Re: National Grid comments on the United States Environmental Protection Agency Proposed Remedial Action Plan for the Gowanus Canal

**Comments on the
United States Environmental Protection Agency
December 2012 Proposed Remedial Action Plan for
the Gowanus Canal Superfund Site**

Submitted April 25, 2013

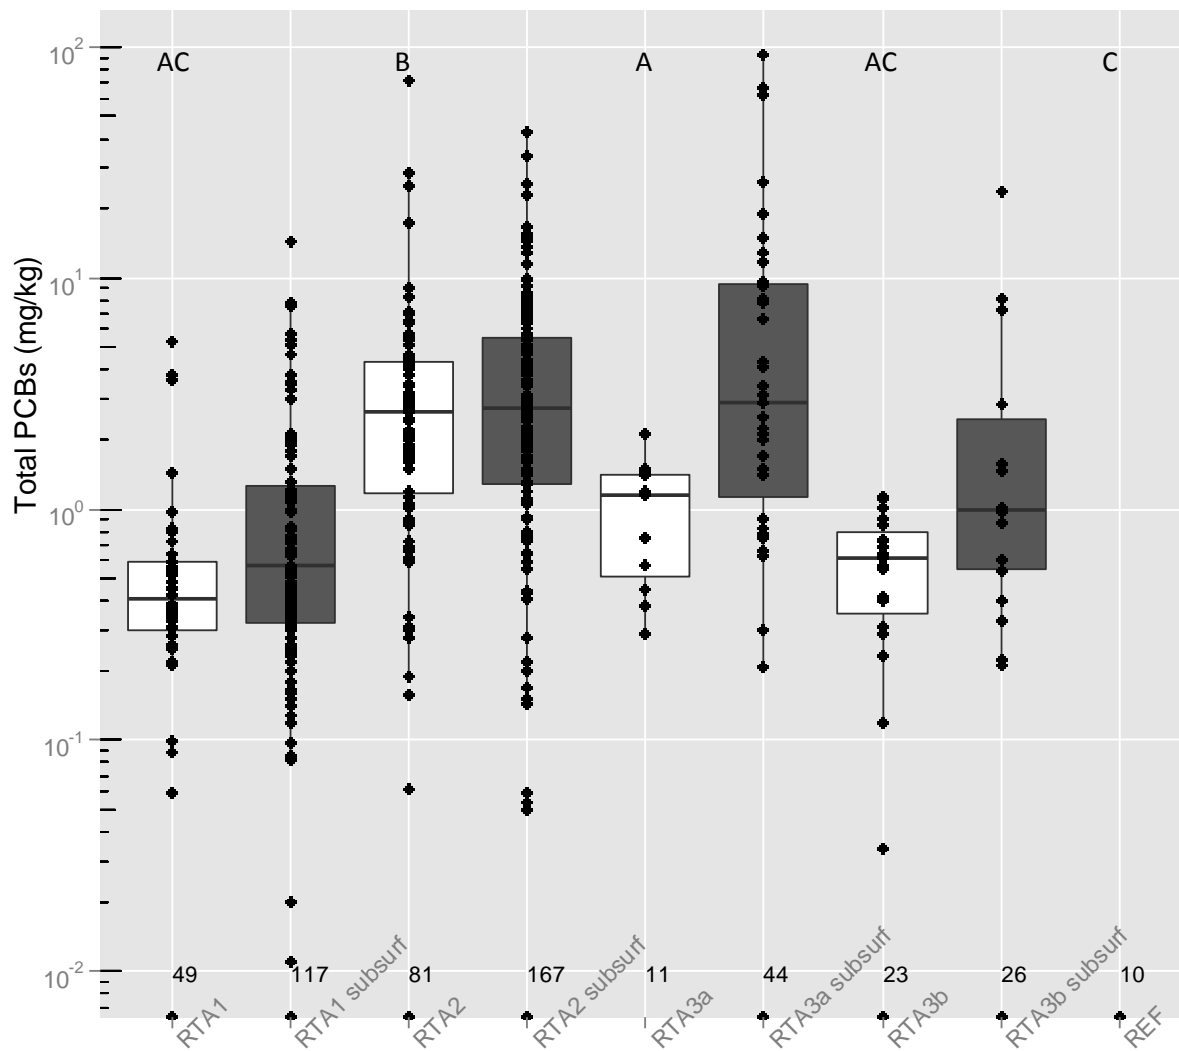
Total PCBs concentrations, measured as the sum of PCB aroclors, in Canal sediments followed a very similar spatial pattern to that of PAH16, with surface concentrations in RTA 3b being similar to RTA 1 and significantly less than RTA 2 (Figure 5 of Appendix L). Patterns in subsurface PCB concentrations were similar but less distinct than the surficial concentrations.

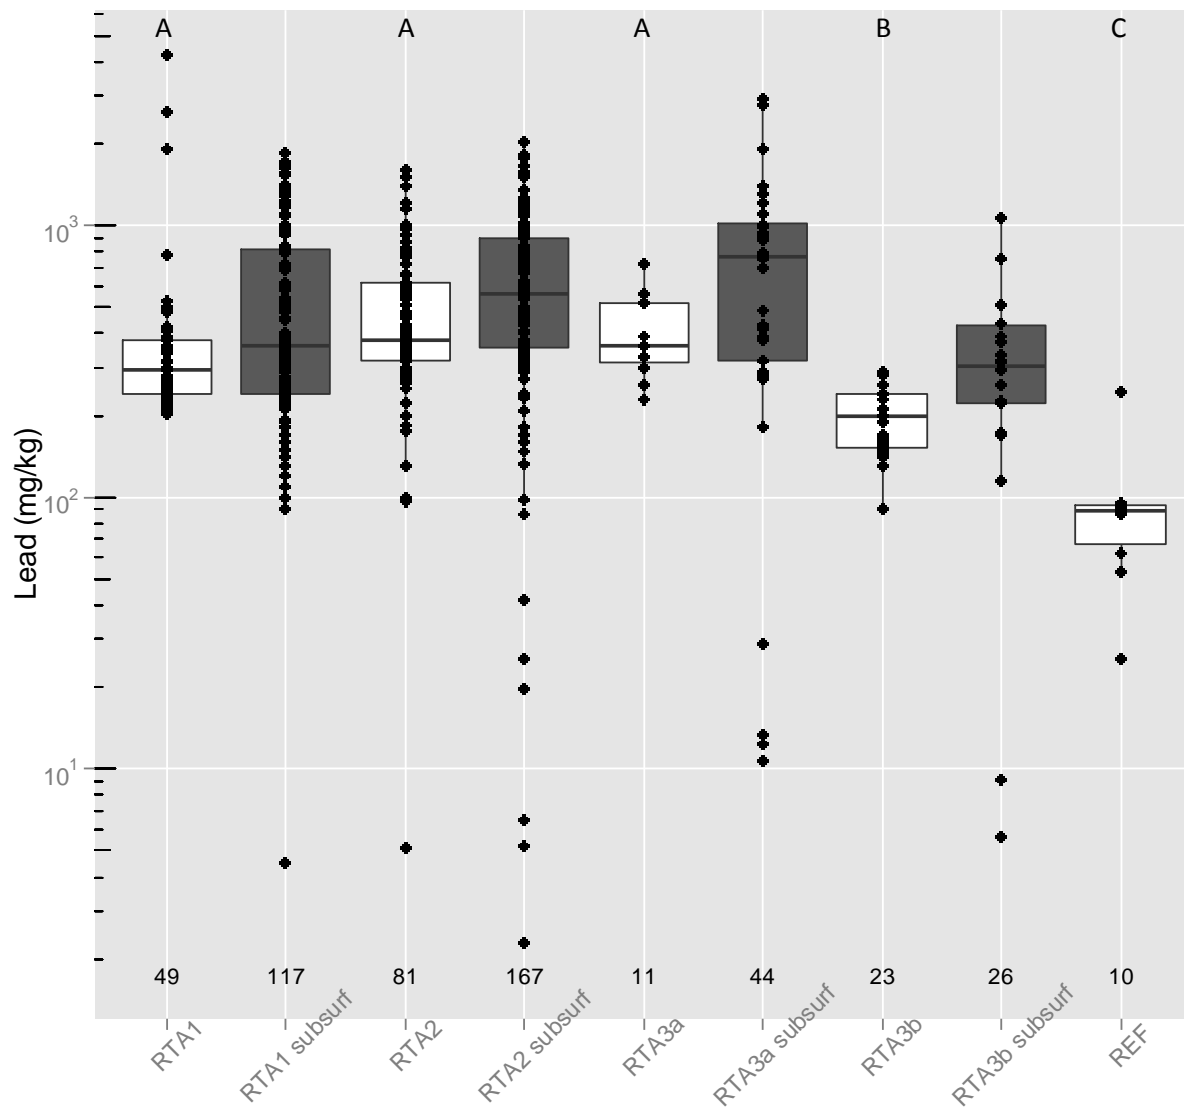
Concentrations of lead in surficial samples in RTA 3b were significantly less than those in RTA 1, 2, and 3a (Figure 6 of Appendix L). Consistent with other analytes, subsurface patterns were similar to surficial patterns, but variability was greater.

Figure 7 PAH Concentrations in RTA 3b sediment

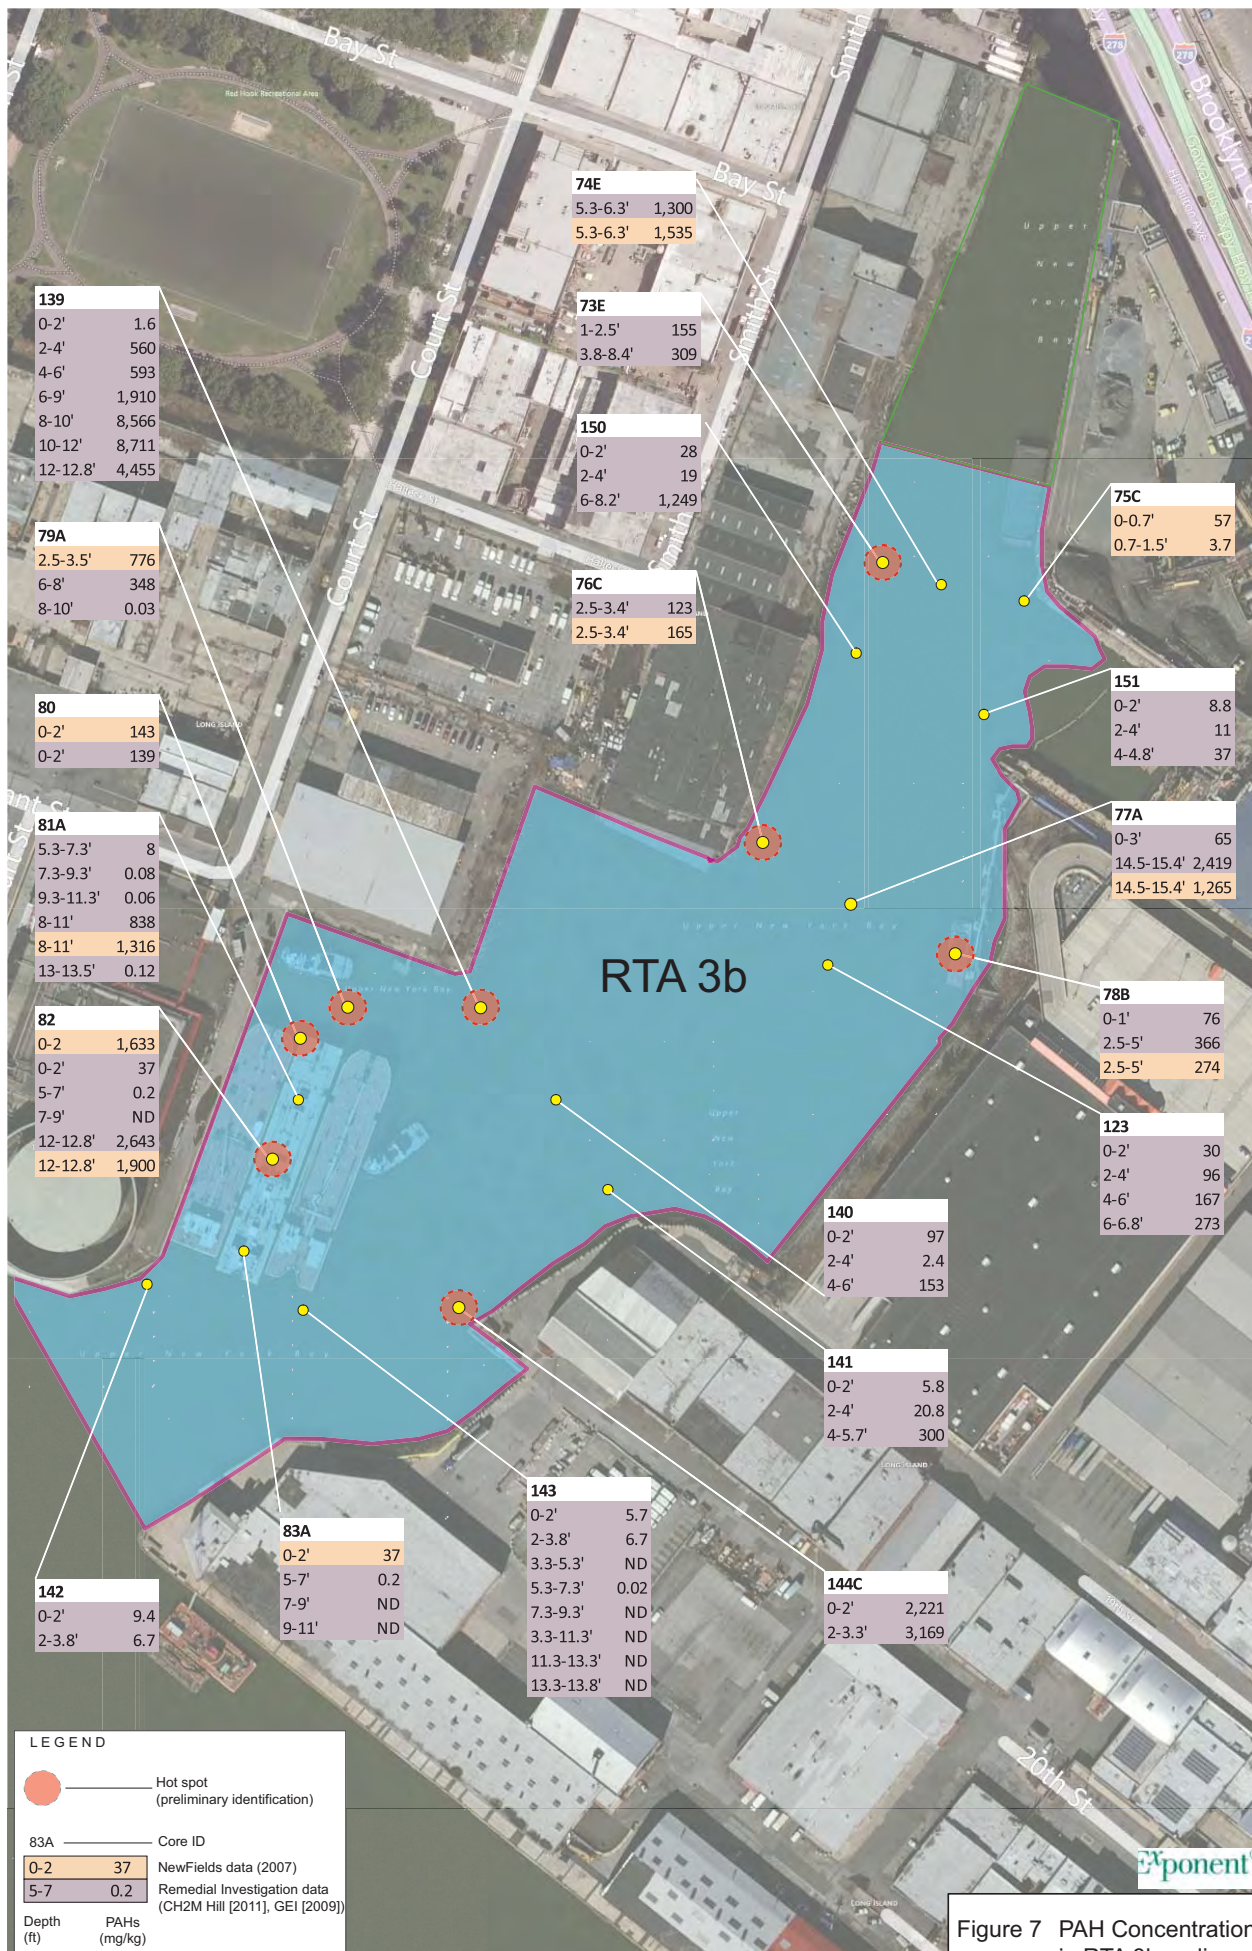
What is more, the highest PAH concentrations in RTA 3b are localized in sediment abutting the boundaries of this RTA. In contrast, the top four feet of soft sediment in the remainder of RTA 3b contains much lower PAH concentrations. Figure 7 of Appendix L shows this pattern of PAH concentrations in sediment cores located within RTA 3b. The “Alternative Remedial Approaches” section below describes in more detail how the distinctive sediment

To illustrate the importance of addressing sediment hot spots, as opposed to dredging the entire soft sediment, the Table 1 in Appendix L compares the average PAH16 concentrations in the hot spots versus the remainder of RTA 3b. Identification of the hot spots in RTA 3b is presented in Figure 7 of Appendix L. PAH16 concentration in the top two feet of hot spots is an average of 808 mg/kg, as compared to 31 mg/kg in other locations. For the two to four feet range in the soft sediment, the PAH16 concentrations averaged 828 mg/kg for the hot spots, versus 23 mg/kg in other locations. This contrast in concentrations calls for defining and addressing hot spots, as opposed to dredging the entire soft sediment.

Figure 9. Benthic invertebrate taxa observed in each remedial target area for the three GEI seasonal sampling events (GEI 2011, 2012a, 2012b).

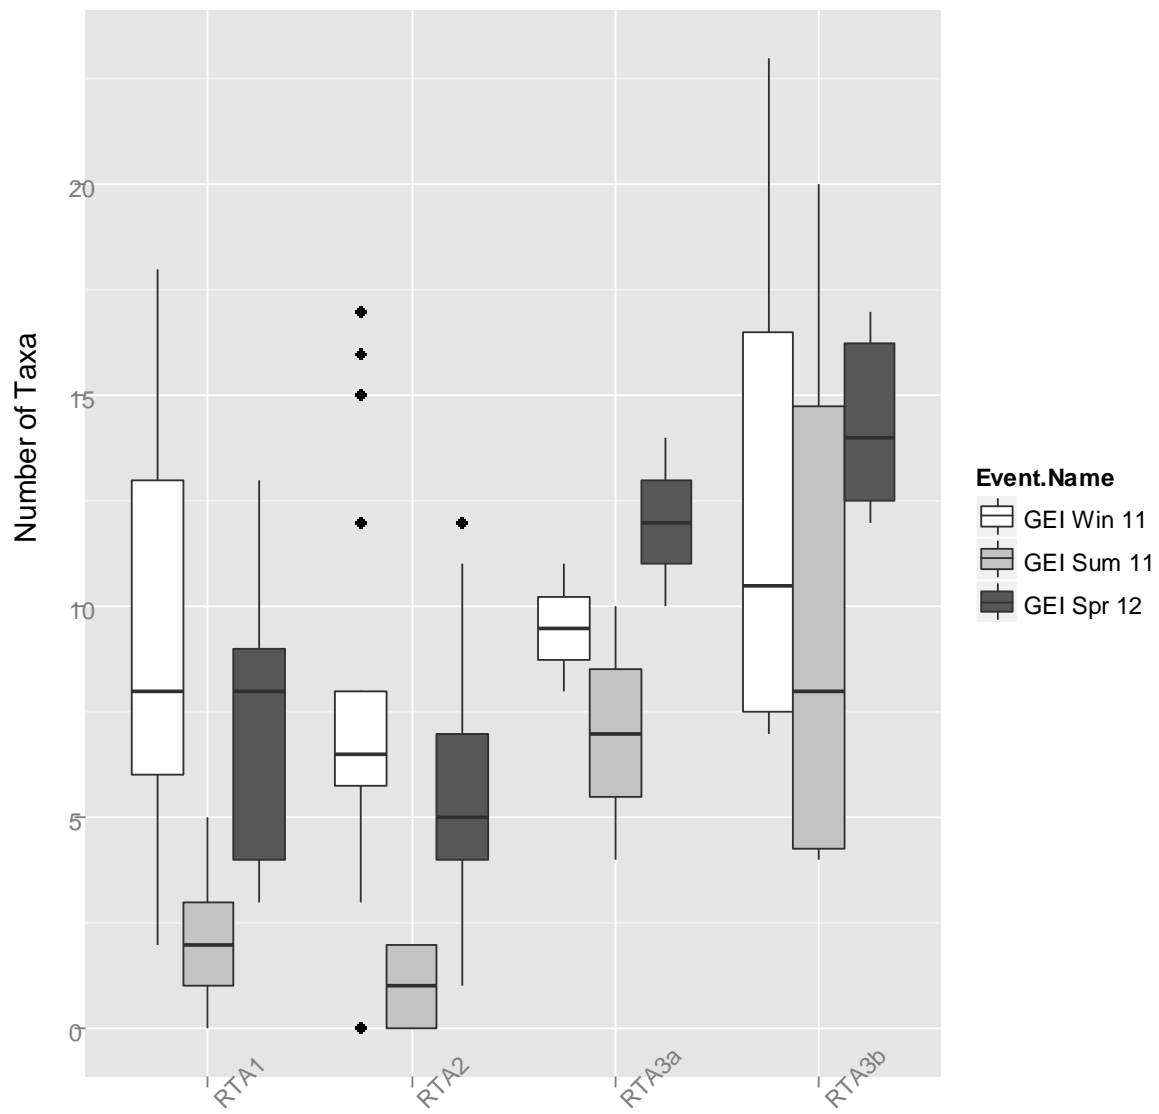
- The greatest number of taxa was observed within RTA 3b where the Canal opens into Gowanus Bay (Figure 9 of Appendix L). Fifty-six of the 86 taxa (70 percent) identified in all the sampling events were observed in RTA 3b.

- RTA 3b maintained a more consistent and stable benthic community across two years and three seasons of sampling. Patterns of number of taxa (Figure 9 of Appendix L), benthic density (Figure 10 of Appendix L), and benthic species diversity (Figure 11 of Appendix L) measured between seasonal events, indicate that the severe benthic community stress that occurred during the summer in most of the Canal had little effect in RTA 3b.
